DATE: 09/05/24
TO: All Bidders
FROM: David Cienfuegos, Purchasing Specialist
SUBJECT: Addendum 1 – Bid 685 Ventura College Admin Building Landscaping

A. Drawings L4.1 Landscape Renovation Plan:

SHEET TITLE
LANDSCAPE DETAILS
 PROJECT
 VENTURA COLLEGE
 ADMINISTRATION BUILDING
 LANDSCAPE RENOVATION
 4667 TELEGRAPH ROAD
 VENTURA, CA 93003

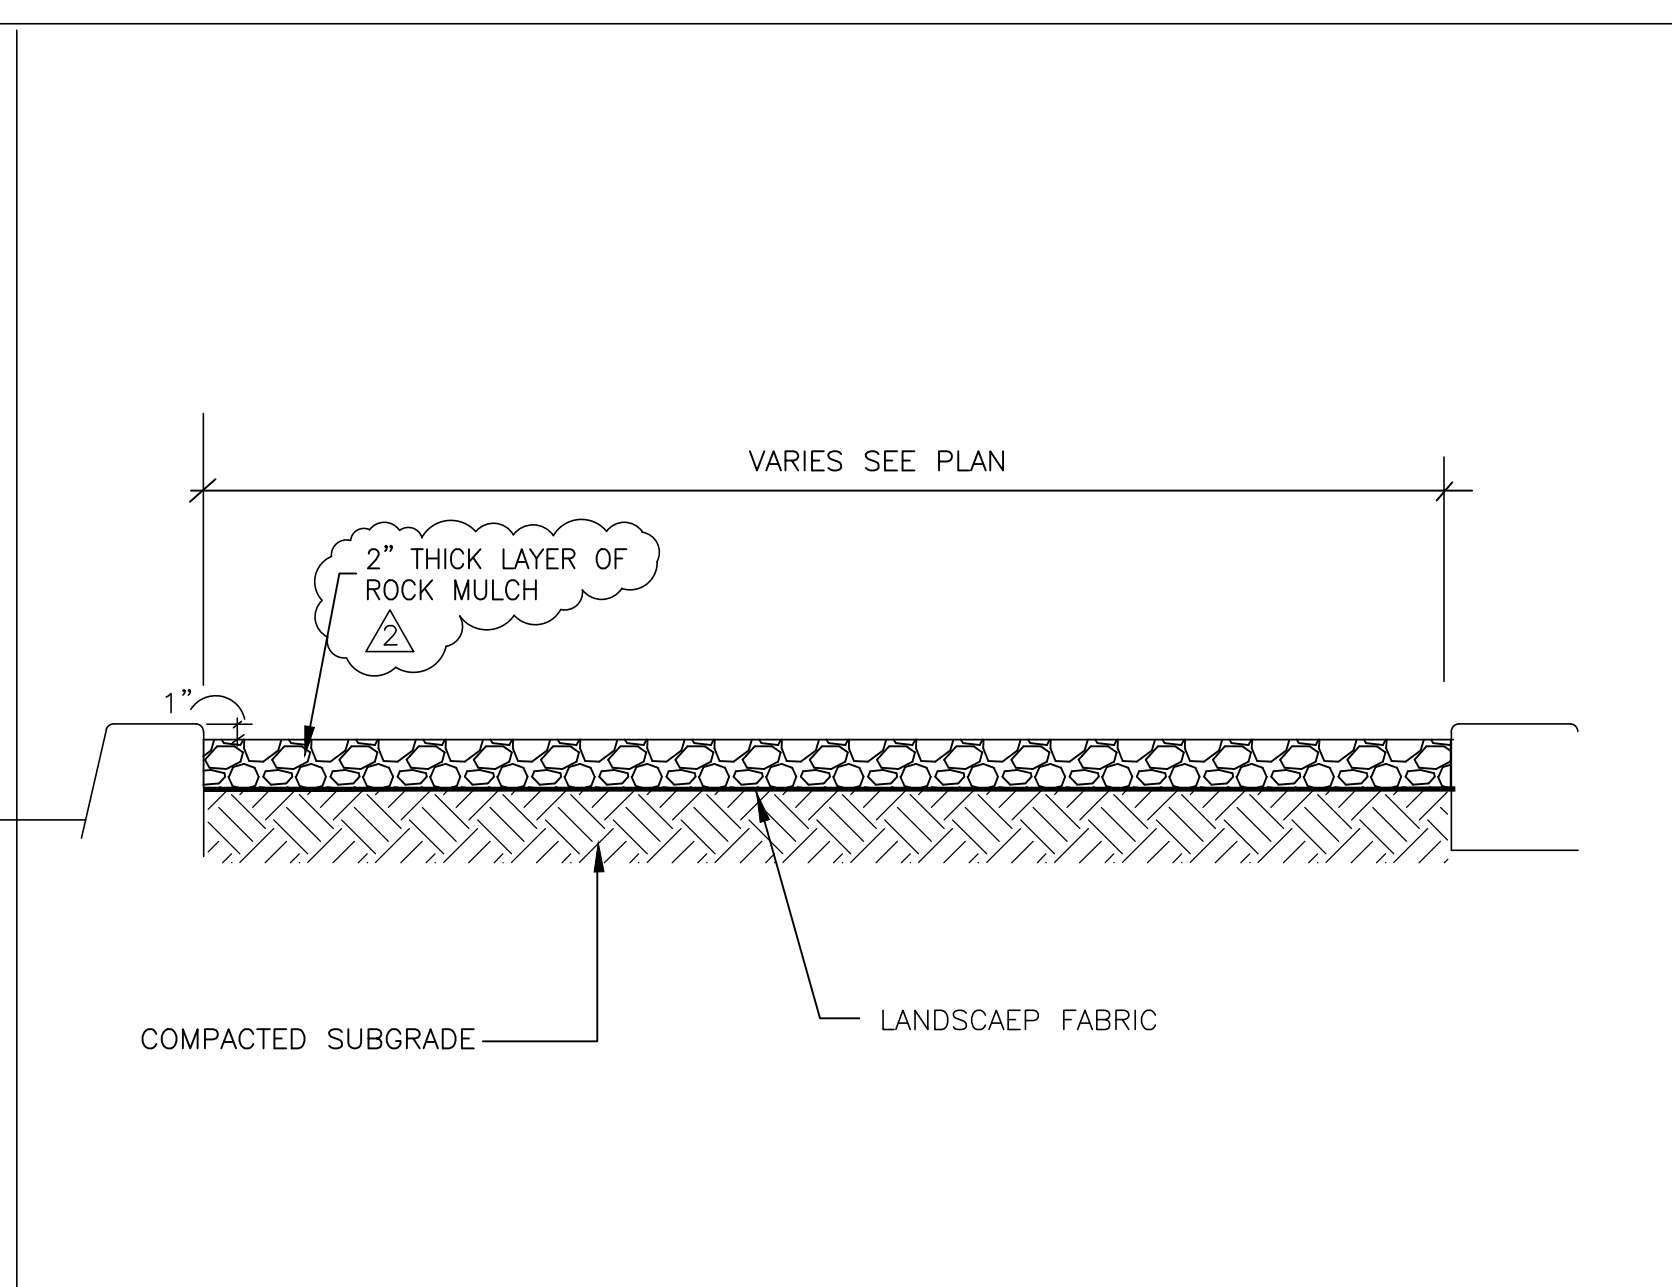
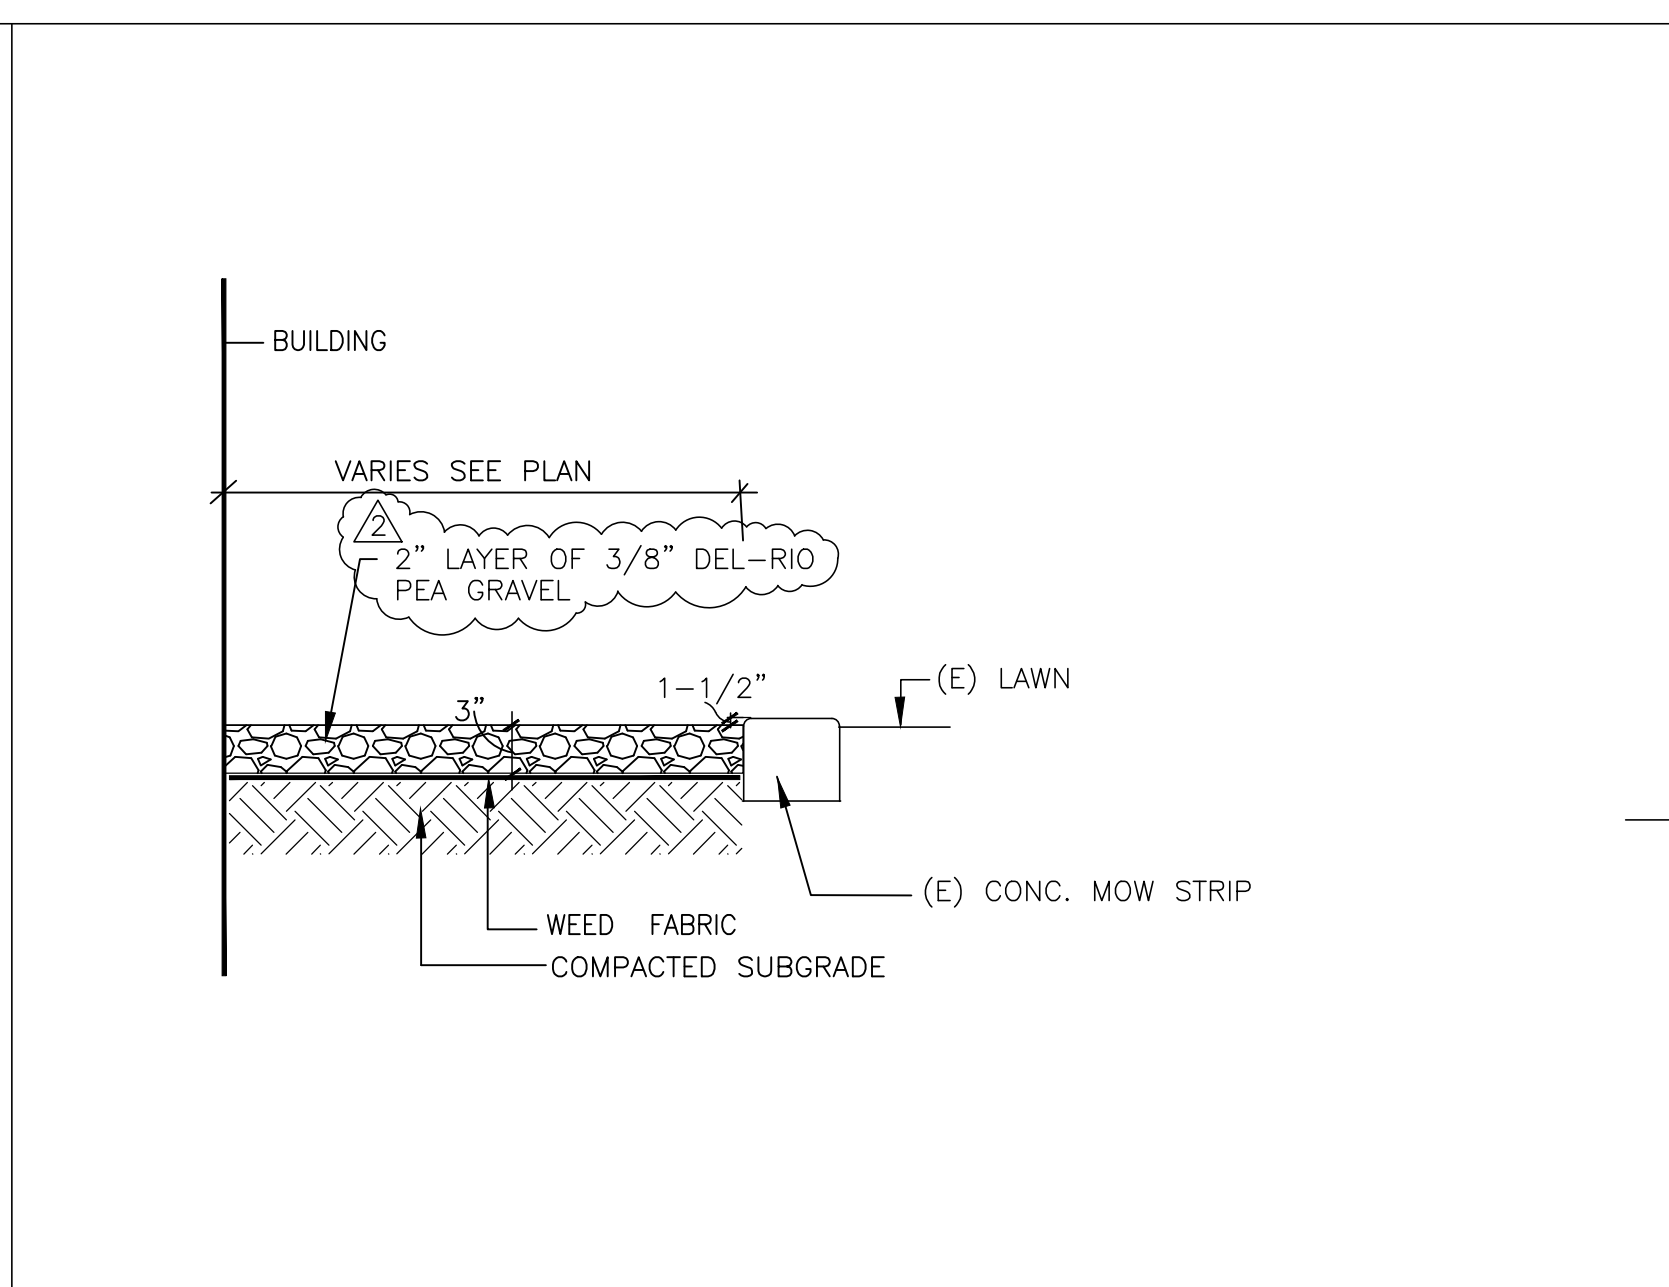
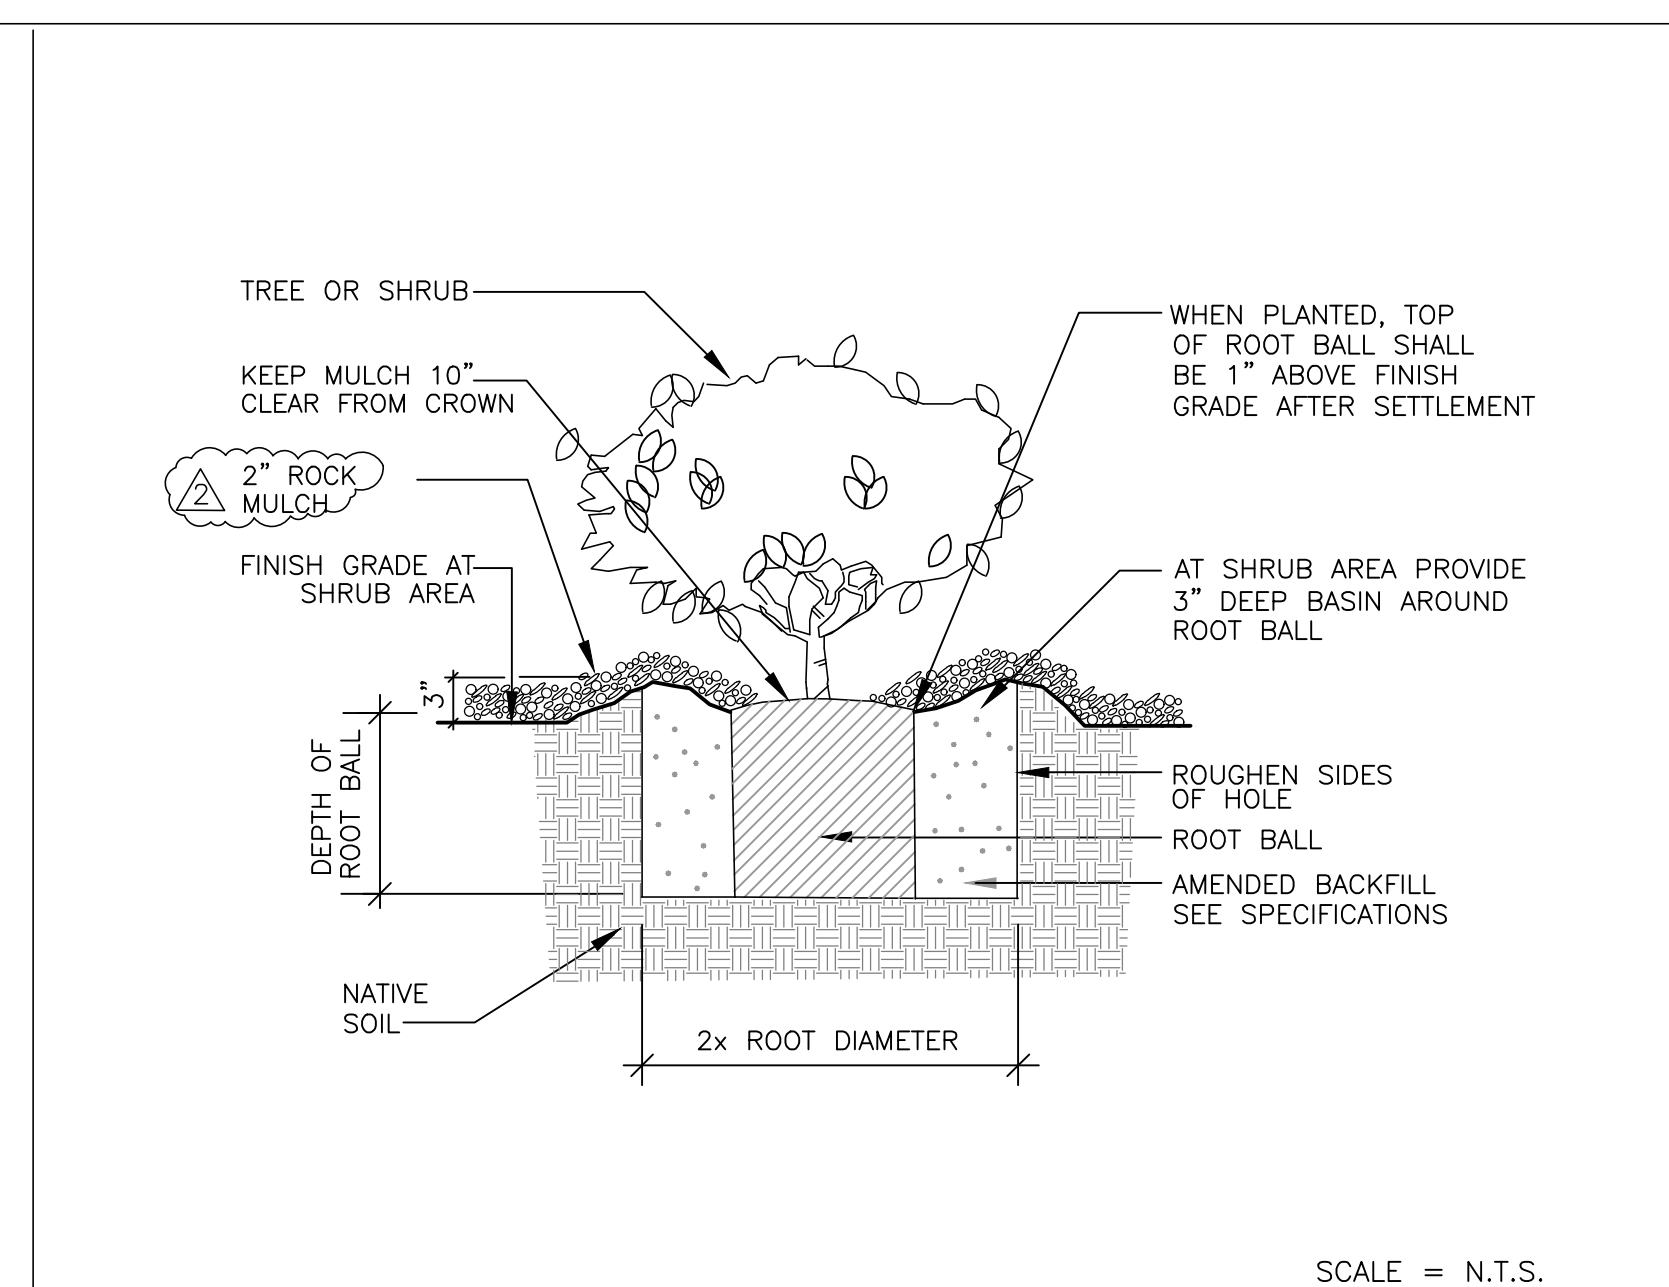
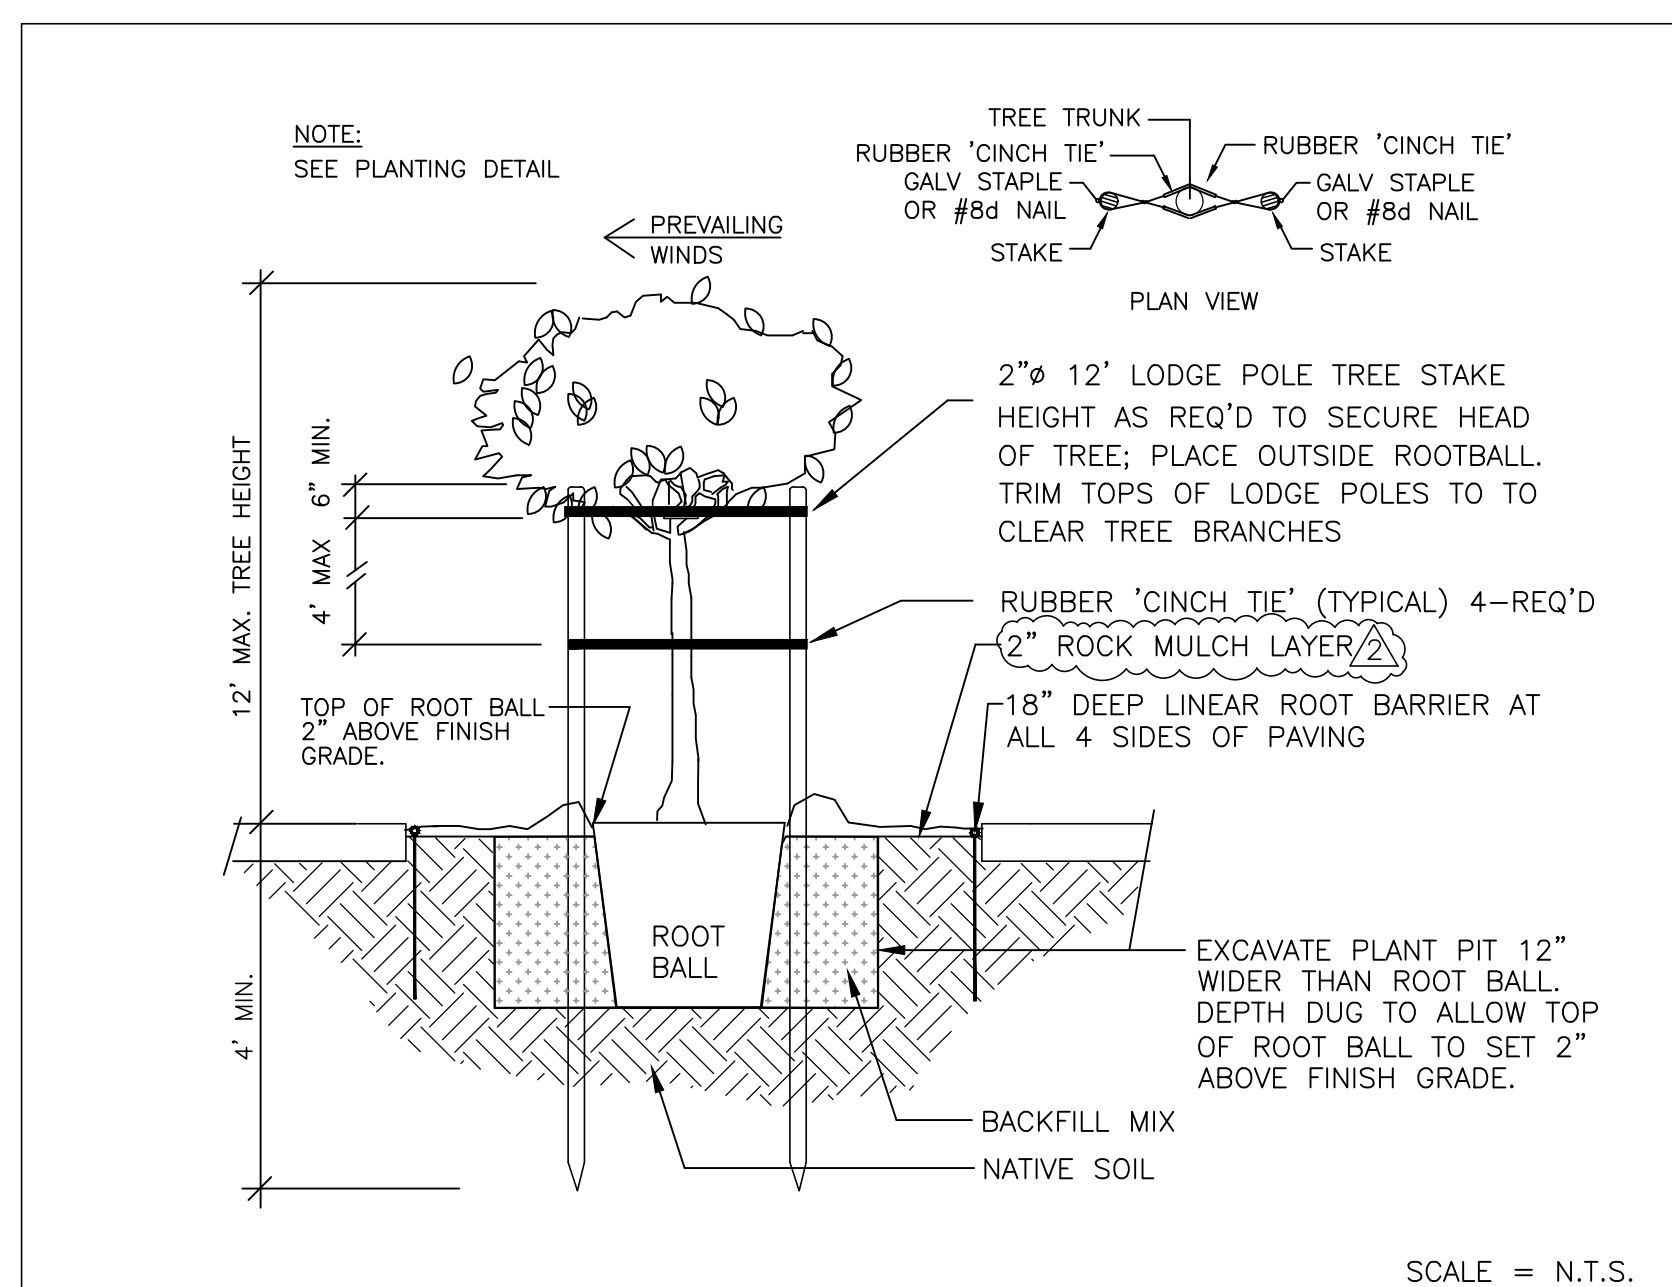
1. Details 1, 2, 3, 4, 5, 6, and 7 were clarified and show a two-inch layer of rock mulch.

1. Detail 4 Concrete Curb clarified with a two-inch layer of rock mulch.

1. Please provide the size for *Cycas revoluta* as shown on plant legend L4.1
 - a. See Addendum 1 Item A-1
2. Legend on sheet L4.1 shows 2-inch layer of pea gravel in planting areas. However, detail 3, 4, 5, 6, 7/L5.2 show 3" layer. Please clarify.
 - a. See Addendum 1 Item A-2 & Item B
3. Spec 329315-05/3.06 requires 2-inch layer of rock mulch throughout shrub areas where indicated on plan. However, detail 6/L5.2 shows black metal edging between rock mulch areas and shrub areas without mulch. Please clarify.
 - a. See Addendum 1 Item A-3
4. Detail 6/L5.2 requires ¼" x 5" black metal edging. However spec 329315-04/2.04 shows 1/8" x 4" black powder coated steel edging. Please clarify.
 - a. See Addendum 1 Item A-3 metal edge deleted.
